PRODUCT BULLETIN

Bulletin No: PB291

New Long G1 Series Blade Sets (Sample image shown)

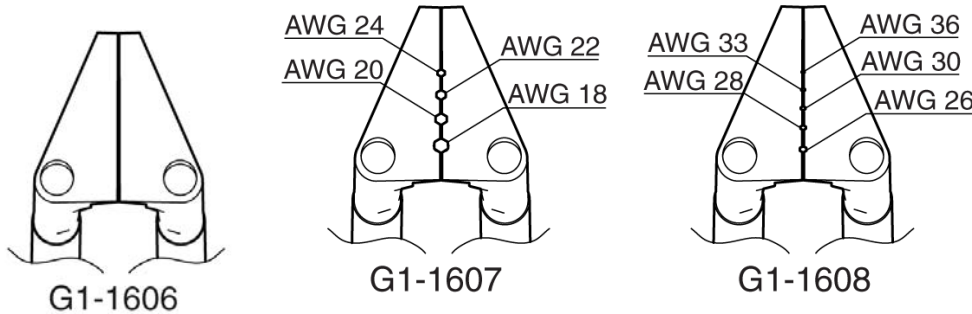
These new Hakko G1 Series Blade Sets have long blade edges for more stable stripping. Duplication of the 24AWG and 26AWG notches have been eliminated while positioning of the notches has been adjusted to improve thermal stripping performance. The extended toe of each blade set can also be used as a hot knife for trimming.
